Rezoning Transportation Analysis

Petition Number: 2019-137

General Location Identifier: 02735346

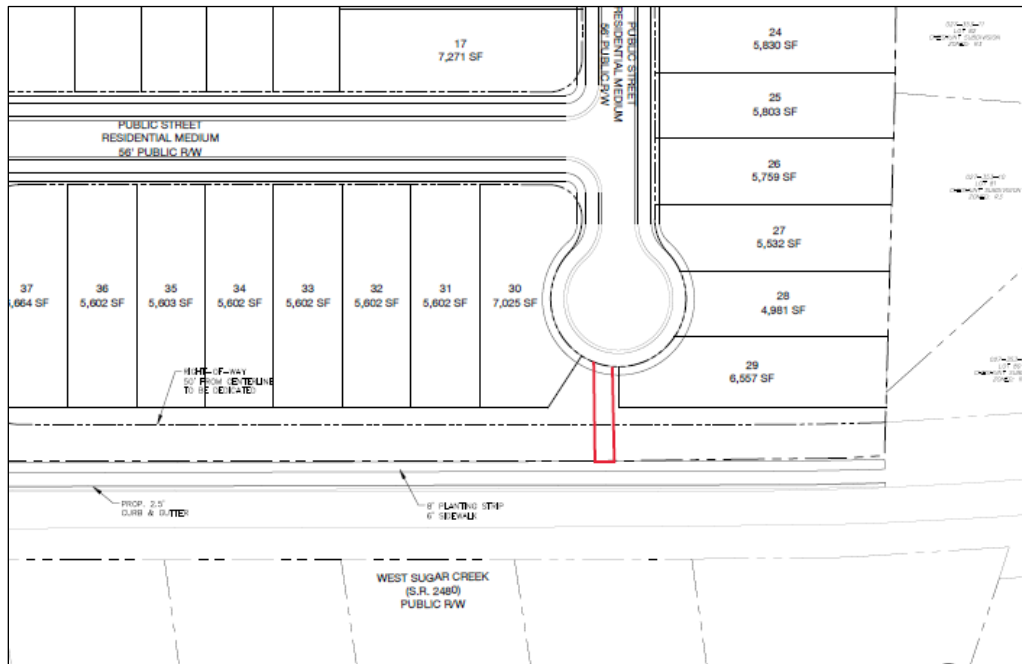
4. The petitioner should revise the site plan and conditional note(s) to install face of C&G 38.5' from centerline. This road is projected to be a 4-lane divided with bike facility.

5. The petitioner should revise the site plan and conditional note(s) to install sidewalk to connect to public sidewalk as shown below.
